**MISSAN SURGICAL HOSPITAL**  
**UNDER THE ECONOMIC SUPPORT FUND**  
**AL AMARAH, IRAQ**

**SIGIR PA-08-165**  
**SIGIR PA-08-167**

**JULY 16, 2009**

## Summary of Report: PA-08-165 and PA-08-167

**Figure 6. Storm water pump station plan**

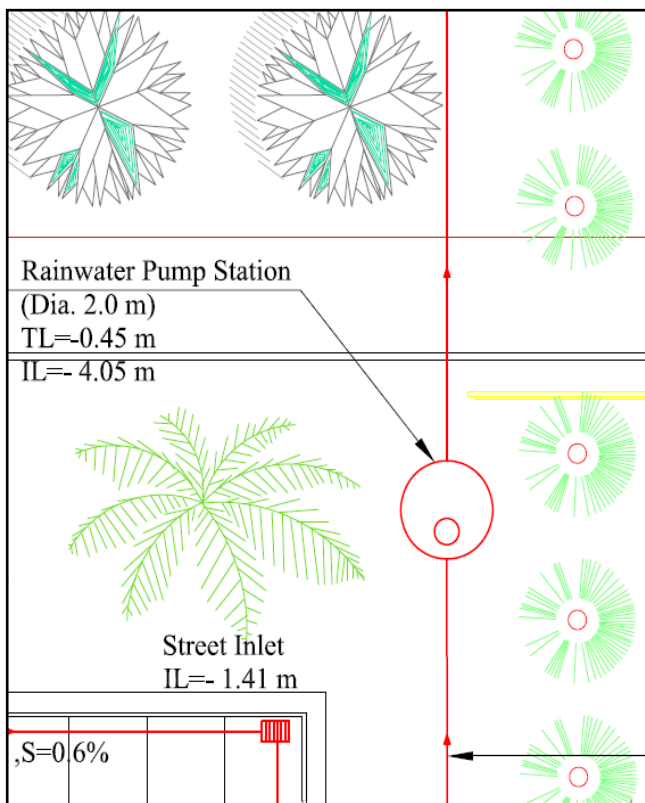
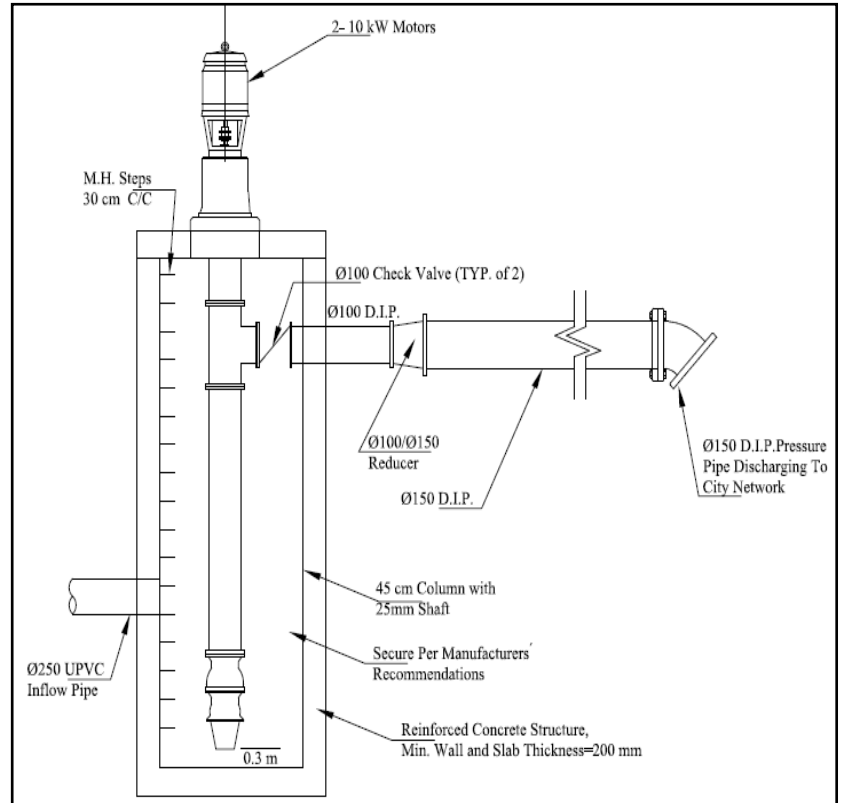
The contractor's plans lacked adequate information for SIGIR to determine how the pumps are controlled or how they will address low-flow conditions. SIGIR is concerned that the high capacity of the pumps combined with the small size of the wet well may result in a rapid cycling of the pumps leading to overheating and premature pump failure.

**Figure 8. Perimeter retaining wall section**

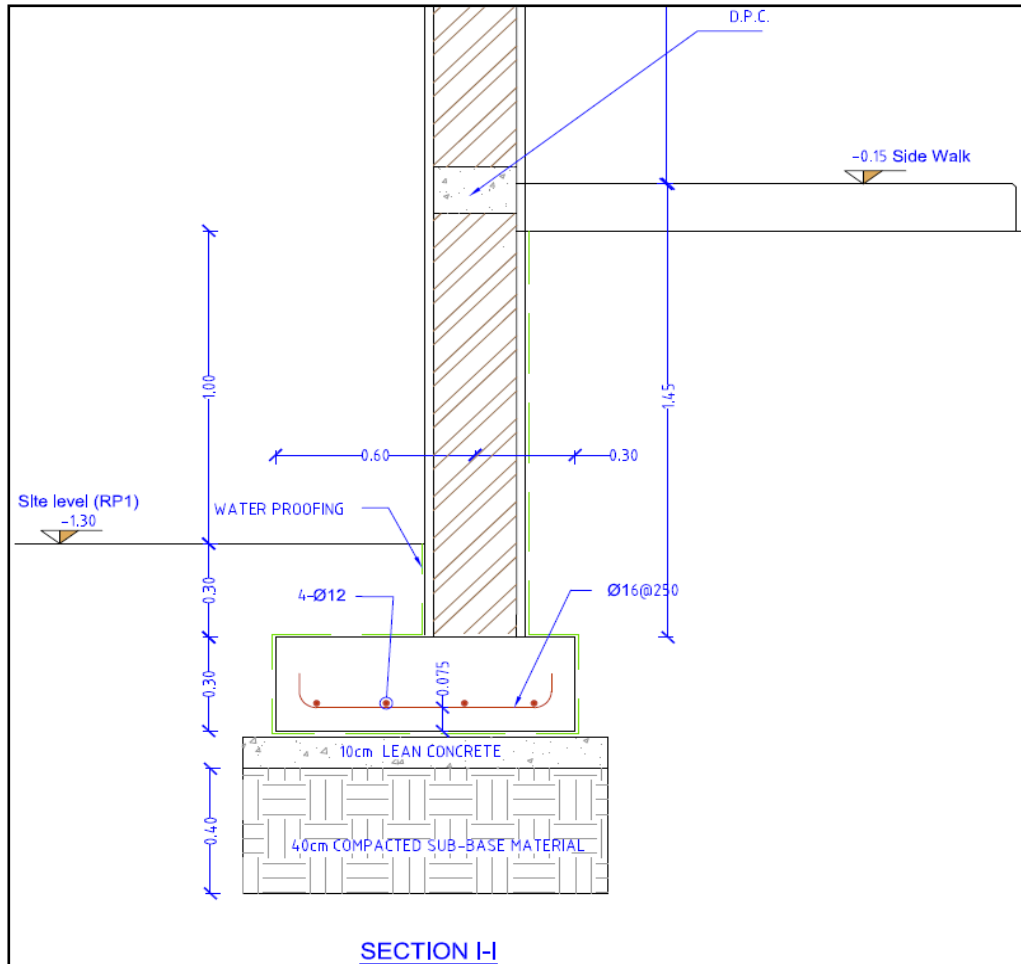
The contractor's design plan detailed the perimeter fence along the north edge of the project site. The plan indicated the application of waterproofing to the portion of the wall below grade (Figure 8). However, the application of waterproofing without the integration of subsurface drainage behind the wall may allow for the buildup of hydrostatic pressure against the wall and possible localized failure of the brick infill.

In addition, the external security fence design did not include any concertina or barbed wire at the top. With only two guard houses (one at each opening to the hospital) and a wall that is only 2m high, concertina wire maybe needed to better secure the facility.

**Figure 9. Location of the two guard houses for the MSH (Courtesy of GRS)**

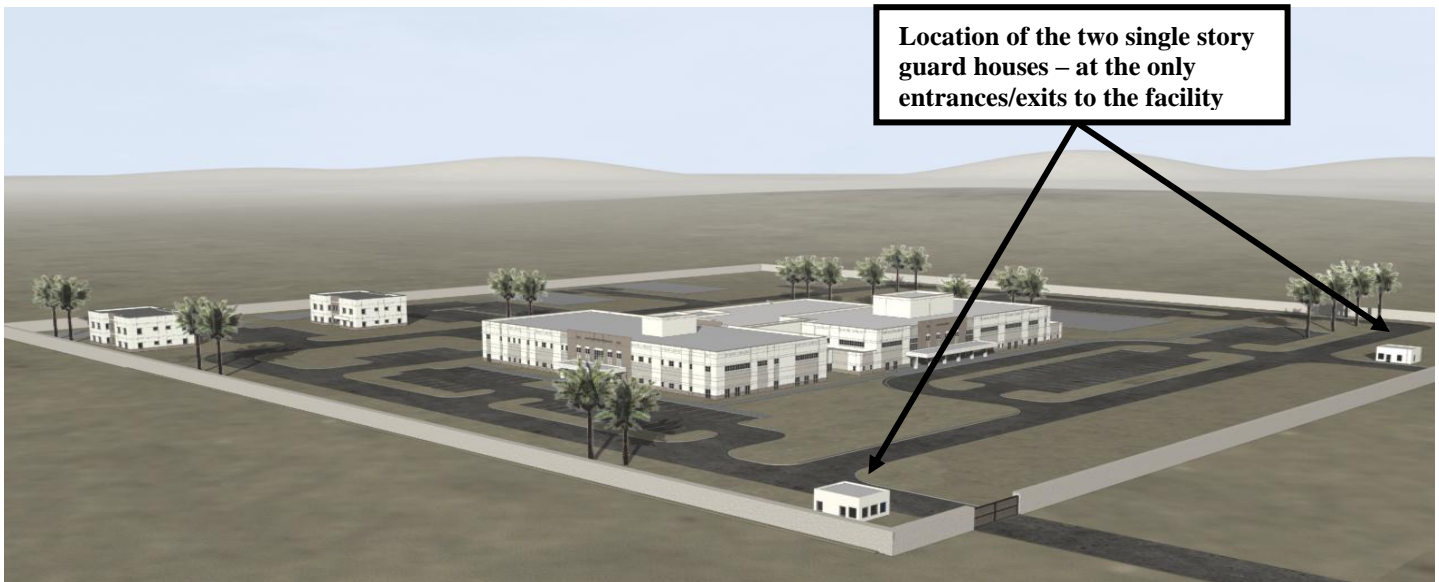
In addition, both the U.S. government and contractor's designs called for only two guard houses (one at each entrance/exit to the hospital – Figure 9). The single-story guard houses provide hospital security by checking people and vehicles as they enter the facility. However, since the guard towers are not elevated and the perimeter security wall is 2m high, the guards will have no ability to monitor any area of the facility outside of the entrances/exits. Consequently, this leaves the perimeter of the hospital site vulnerable to attack. Considering the overall size of the project site is 62,500 m<sup>2</sup> and the main hospital buildings obstruct a significant portion of the view

from the guard house, additional guard houses and elevated guard towers are necessary to provide adequate security.

Figure 10. Contractor’s river intake detail design (Courtesy of GRS)

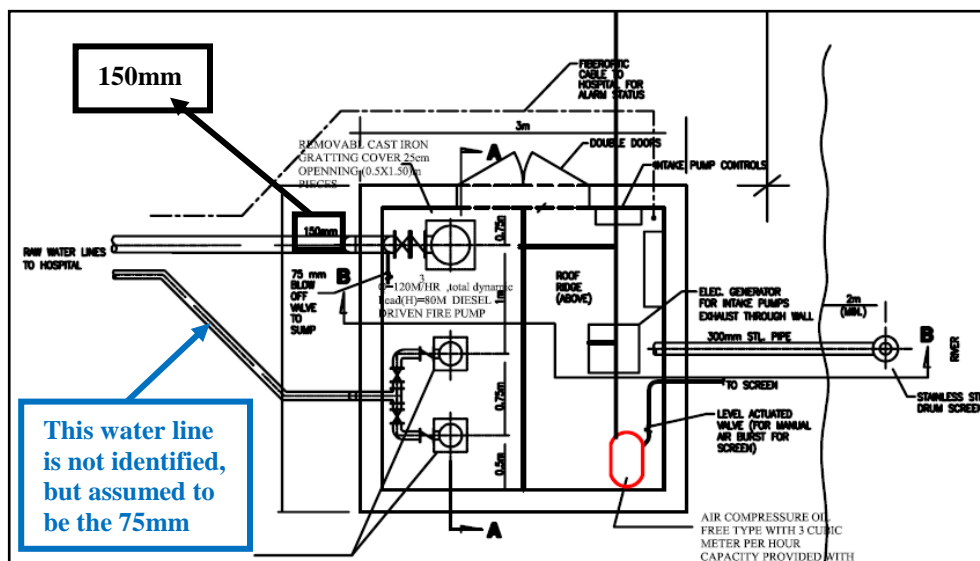
In addition, GRS provided two designs drawings for the raw water intake; both designs dated 30 April 2008. These designs, dated 8 months prior to SIGIR’s site visit, were not part of the original project file documentation provided to SIGIR; instead GRS provided these drawings after the exit conference. After reviewing both designs, SIGIR determined them to be, at best, conceptual designs because they lacked specific details on piping elevations and lengths, electrical systems designs, access roads, flooding levels, and grading requirements.

Further, when placed together, the two designs clearly show a lack of detail and cohesion. For example, the SOW required two water lines – one for water processing and one for fire suppression. The “River Intake 6-5 River Intake (1)” design identified only the 150 mm water line; while the “site-maissan Water(27) WATER FIRE(27)(1)” design only identified the 75 mm water line (Figures 10-12). Also, since the security wall has already been constructed, the contractor will now have to excavate under it in order to route the water lines under the wall. In addition, the exact location of the river intake has yet to be determined; instead GRS AAO stated it will be “located approximately where the Tigris [River] and Al Kahla [River] intersect.”

Figure 14. Contractor's overall wastewater treatment plant schematic drawing (Courtesy of GRS)

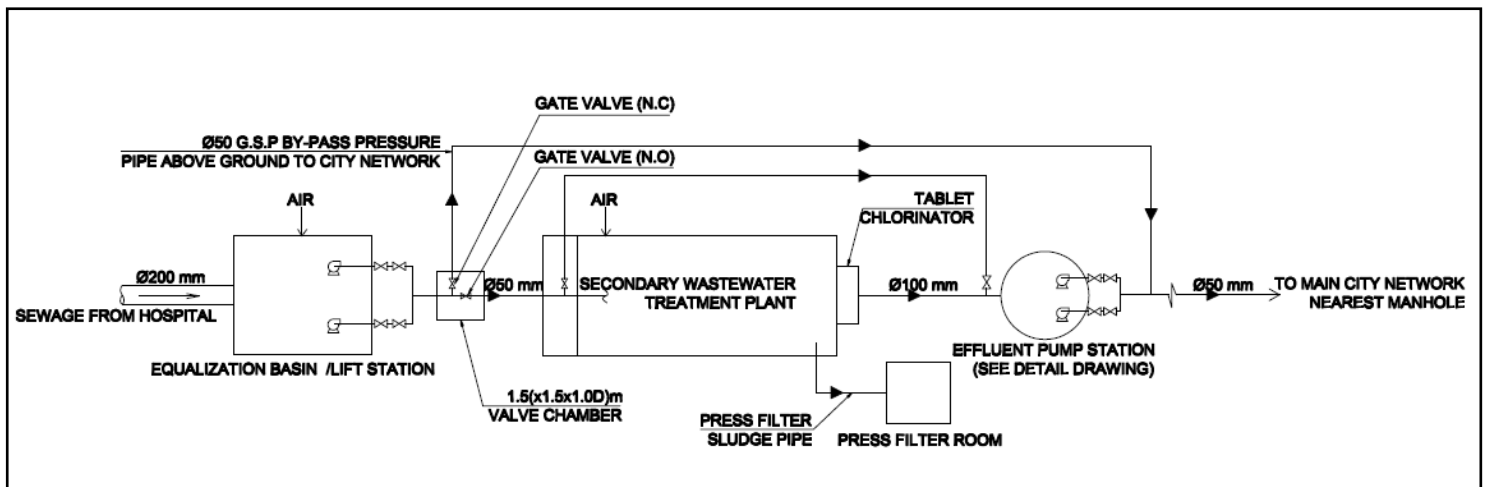
Similar to the water supply system, the wastewater system design lacked significant details, such as the alignment and outfall of the sewage leaving the hospital site. Figure 14 shows the overall wastewater treatment plant schematic drawing, which indicates that the sewage leaving the hospital will be deposited directly into the “main city network nearest manhole” without identifying the exact location and distance to the nearest manhole, the size, elevation, and condition of the main city network sewer pipe, and whether or not an analysis has been performed to determine if the existing city network system can accommodate the significant additional flow the hospital will provide. To ensure that sewage does not back up into the hospital or in nearby neighborhoods, it is important that the network have the capacity to handle the additional flow.

**Figure 17. Comparison of typical design column section versus column as constructed**

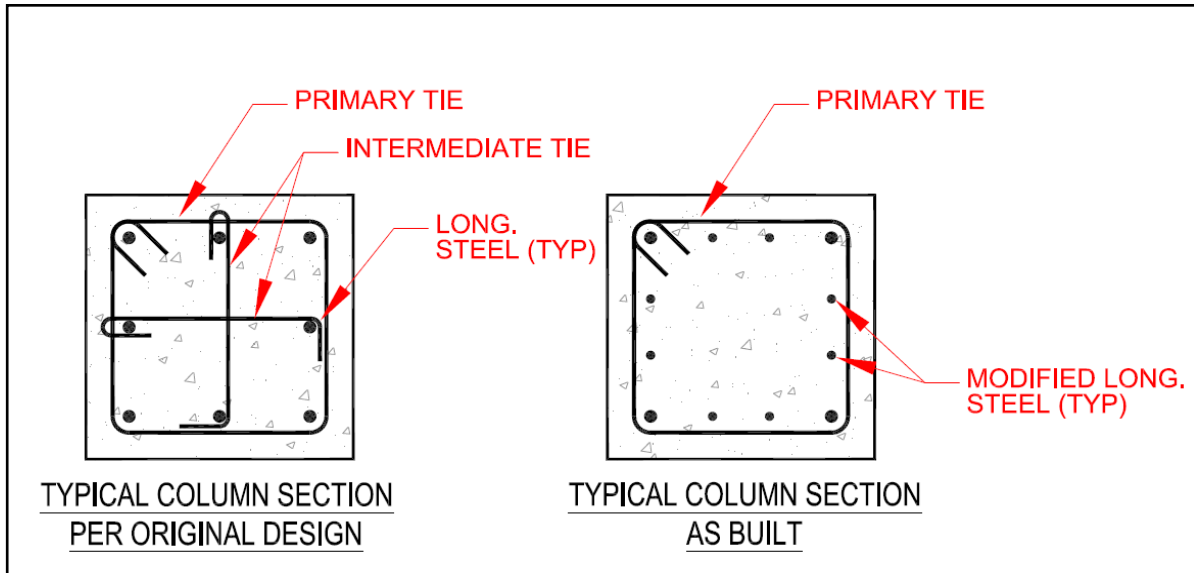
In addition, SIGIR noted that the reinforcing configuration used in the construction of the reinforced concrete columns varied from the configuration specified in the design drawings. Figure 17 clearly illustrates the difference between the design drawing and actual construction of the reinforcing configuration. The design drawing required three separate pieces of reinforcement bar along with two ties (primary and intermediate). The primary ties a steel bar around the perimeter of the vertical reinforcement bars; while the intermediate ties a steel bar from the middle reinforcement bar of one side to the other. However, the contractor opted to use four vertical pieces of reinforcement bar along with a primary tie around the perimeter.

In order to more clearly illustrate the difference in the design versus actual construction, Figure 17 is the reinforcement configuration from the design drawings; while Figure 17 and Site Photo 5 document the actual construction performed by the contractor.

After reviewing the design drawings, it appeared the contractor referenced the Iraqi Building Code Requirements for Reinforced Concrete (IBCRRC). Specifically, IBCRRC, section 10.6.5.3 states:
